SLICK SB3-08B

Service Bulletin

SUBJECT: Mandatory inspections on all Slick 4200/6200/4300/6300 series and LASAR™ 4700/6700 magnetos

Bulletin SB3-08B supersedes bulletin SB3-08A. The bulletin has been updated to replace all references to Unison Industries with Champion Aerospace and to provide instructions for inspection of coil tab wear and to remove package date requirement on packages in Champion packaging.

Bearing Bar
Figure 2

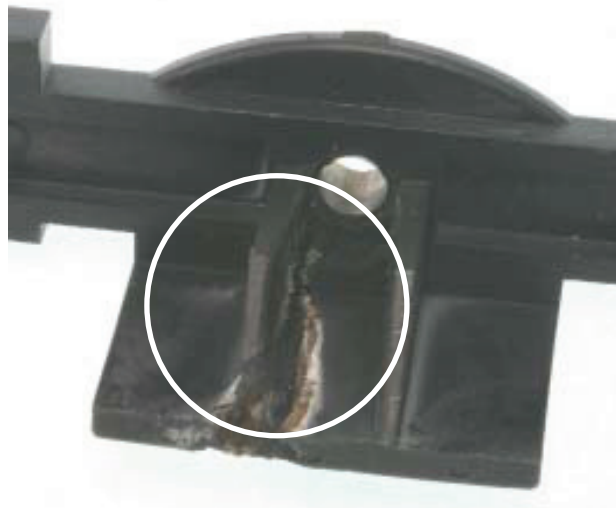
- Inspect bearing bar for evidence of brush residue contamination, burning, or arcing. See Figure 2. **REPLACE DISTRIBUTOR BLOCK ASSEMBLY PER THE APPLICABLE MAINTENANCE AND OVERHAUL MANUAL IF THERE IS ANY EVIDENCE OF ELECTRICAL ARCING OR BURNING.** The new bearing bar can be identified by either the manufacturer-dated packaging, or visually by noting the dams.

Unacceptable
(Developing bearing bar failure)

Coil Tab Positioning
Figure 4

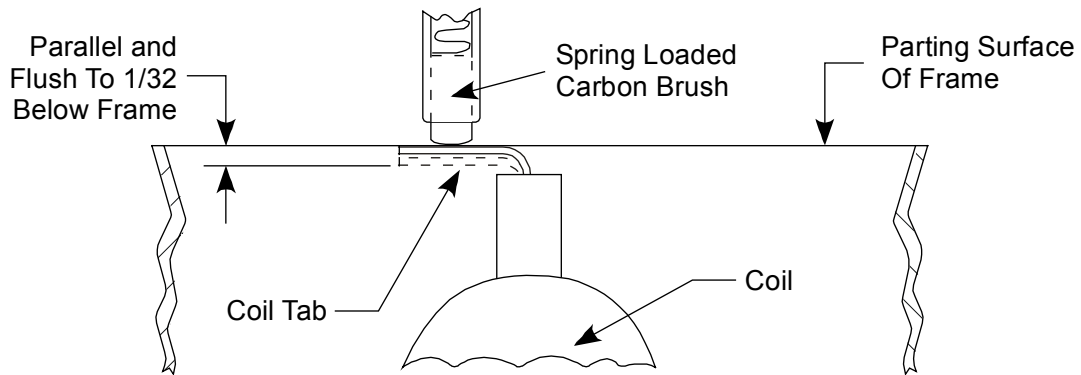
CAUTION: IF THE COIL TAB PROTRUDES ABOVE THE MAGNETO FRAME, IT CAN MAKE DIRECT CONTACT WITH THE DISTRIBUTOR GEAR AXLE AND CAUSE THE MAGNETO TO MALFUNCTION.

- Prior to installing distributor block, make sure coil tab is parallel to and flush with frame mating surface to within 1/32 inch. See Figure 4.
